**PCN#20191212001.1
New Tray for Select Devices
Final Change Notification**

Date: January 14, 2020
To: Newark/Farnell PCN

PCN Number:	20191212001.1	PCN Date:	Jan. 14, 2020
Title:	New Tray for Select Devices		
Customer Contact:	PCN Manager	Dept:	Quality Services
Proposed 1st Ship Date:	April 14, 2020		
Change Type:			
<input type="checkbox"/>	Assembly Site	<input type="checkbox"/>	Assembly Process
<input type="checkbox"/>	Design	<input type="checkbox"/>	Assembly Materials
<input type="checkbox"/>	Test Site	<input checked="" type="checkbox"/>	Electrical Specification
<input type="checkbox"/>	Wafer Bump Site	<input type="checkbox"/>	Mechanical Specification
<input type="checkbox"/>	Wafer Fab Site	<input type="checkbox"/>	Test Process
<input type="checkbox"/>		<input type="checkbox"/>	Wafer Bump Material
<input type="checkbox"/>		<input type="checkbox"/>	Wafer Bump Process
<input type="checkbox"/>		<input type="checkbox"/>	Wafer Fab Materials
<input type="checkbox"/>		<input type="checkbox"/>	Wafer Fab Process
<input type="checkbox"/>		<input type="checkbox"/>	Part number change

Group 1 Change Description - 14 x 14 TQFP Tray Change:

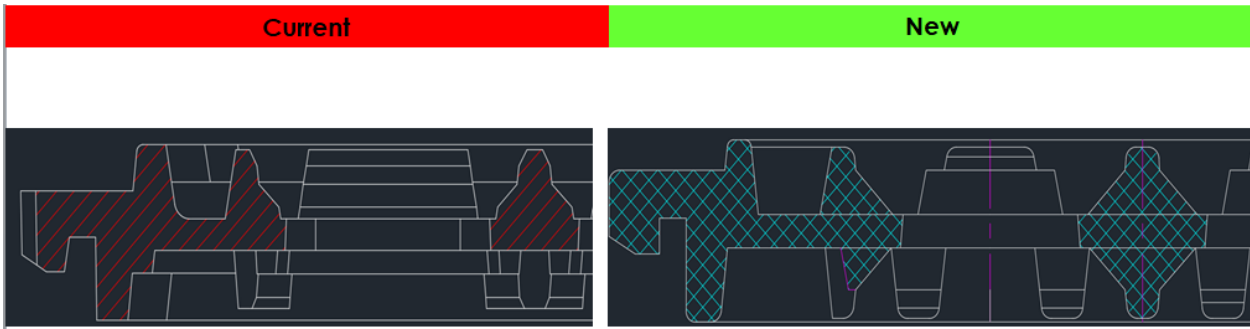
Texas Instruments is pleased to announce the qualification of a new tray for the devices listed below. A comparison summary of the tray differences as follows:

4223432-0001	4224972-0001
Supplier	UBOT	Peak
Floor design	Circular square	Octagon
Cavity size	16.55 +/- 0.08	16.10 +/- 0.08
Seating height	1.52 mm (top) 0.75 mm (bottom)	1.5 mm(top) 0.9 mm (bottom)

Reason for Change:
New tray offers improved centering of device in tray pocket
Anticipated impact on Fit, Form, Function, Quality or Reliability (positive / negative):
None
